MODIFICATION INSTRUCTIONS

KODAK MINILOADER 2 PLUS, MODELS STAND-ALONE, M35-M & 480RA

MODIFICATION No. M04

To reduce the speed of the TILT MOTOR by fitting a different GEARBOX. The new GEARBOX has a ratio of 80:1 compared to the 40:1 ratio of the old GEARBOX. At present the tilt speed control POTENTIOMETER setting is critical. If the speed is set too low, the TILT MOTOR can stall and give error code *23*. If the speed is set too high the TILT MOTOR can over-run and cause the FILM to be caught on the edge of the MAGAZINE or on the multiple film DETECTOR. On some units, it was impossible to obtain a satisfactory setting.

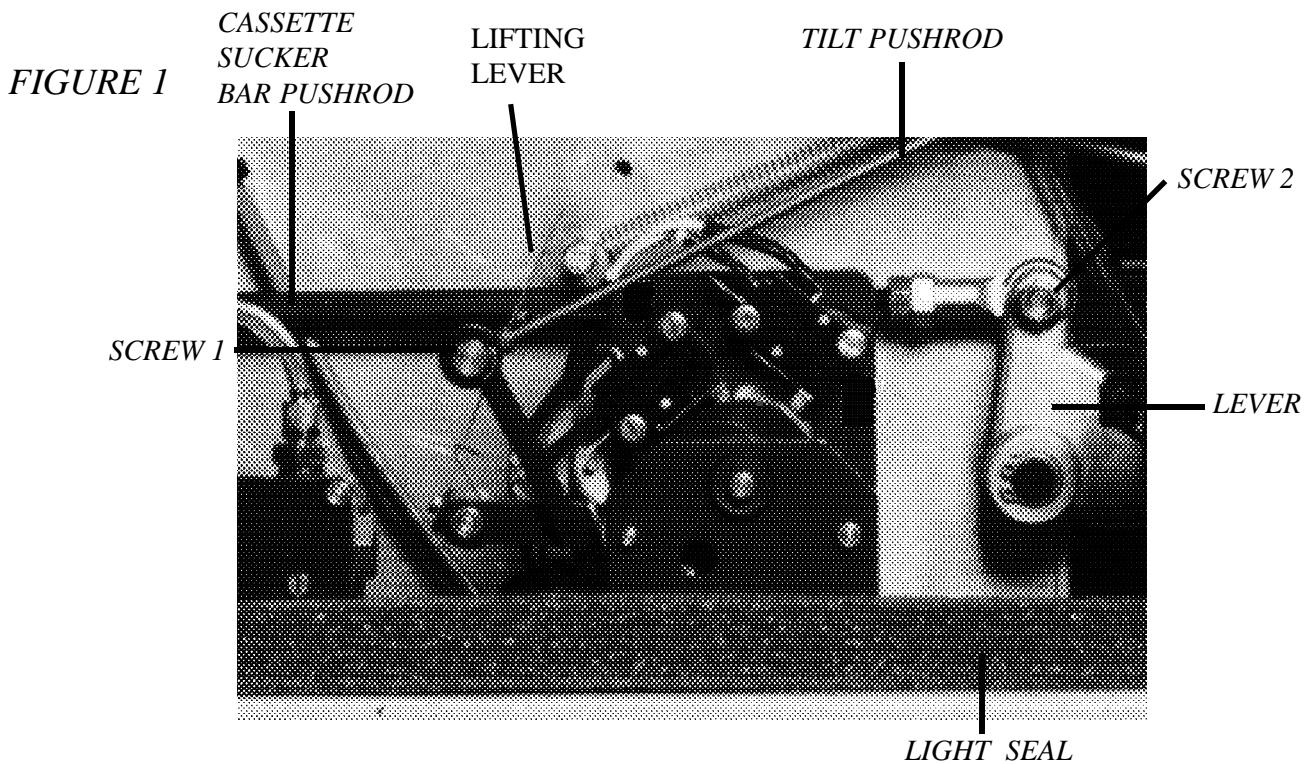
1. Switch off the MINILOADER, and remove the TOP COVER and the left (looking from the front) SIDE PANEL.
2. Disconnect the TILT PUSH ROD by removing the M4 SCREW (SCREW 1 in FIGURE 1) on the TILT LINKAGE.
3. Disconnect the CASSETTE SUCKER BAR PUSH ROD by removing the SCREW (SCREW 2 in FIGURE 1) from the LEVER. CAUTION - support the SUCKER BAR (do not touch the SUCKERS) as you remove the SCREW, and gently lower the SUCKER BAR to the CASSETTE CONVEYOR BELT as it becomes loose. Do not attempt to disconnect the CASSETTE SUCKER BAR PUSH ROD by unscrewing the PUSH ROD, as you will destroy the adjustment.

4. Make a note of where the four WIRES are connected to the MICROSWITCHES and disconnect them. If the wires are soldered, cut them off close to the connectors.
5. Carefully peel back the LIGHT SEAL to gain access to the SCREWS that secure the TILT MOTOR ASSEMBLY and remove them.
6. By rotating the complete assembly by 90 degrees it is now possible to withdraw the TILT MOTOR ASSEMBLY from the MINILOADER.
7. Remove the LIFTING LEVER (see FIGURE 1) from the old TILT MOTOR ASSEMBLY and fit it to the new assembly.

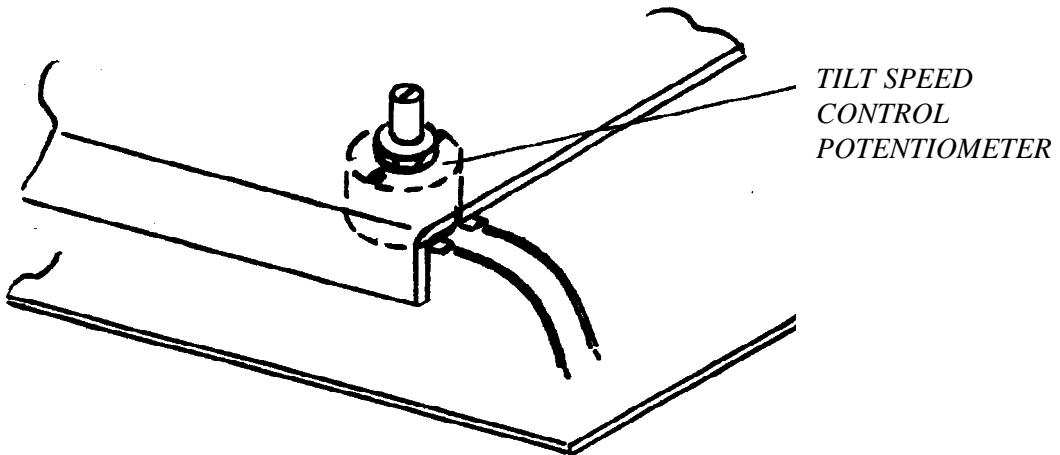
10. If necessary adjust the TILT SPEED CONTROL POTENTIOMETER see FIGURE 2. The setting on the POTENTIOMETER should be virtually fully clockwise, giving nearly the highest speed. If the TILT MOTOR still over-runs, reduce the speed of the MOTOR by turning the POTENTIOMETER counter-clockwise.
